Air Conditioning Validation

Project Address	-Withheld-
Client	-Withheld-
Date of Validation	-Withheld-
Equipment Manufacturer	Mitsubishi Electric

A Validation Survey was carried out to 8 Mitsubishi Electric VRF-Type Air Conditioning Systems serving 8 floors, on -date withheld-.

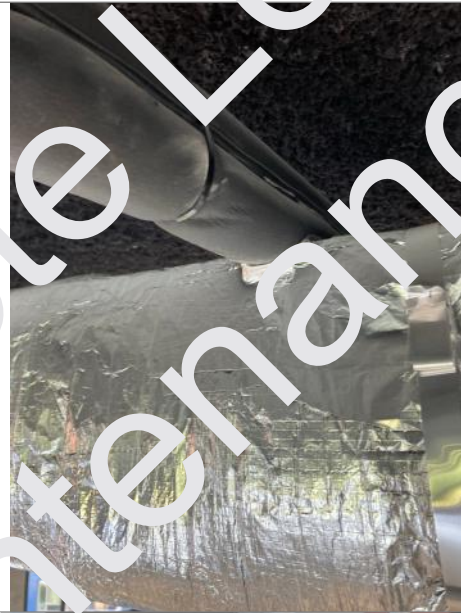
Metal drop rod is causing damage to pipework insulation.

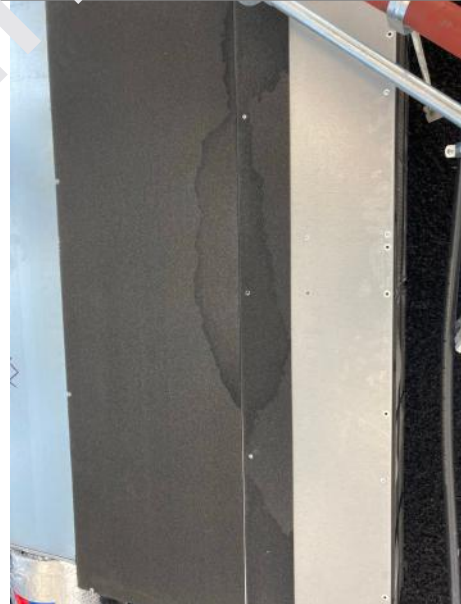
Signs of water damage on Fan Coil Unit.
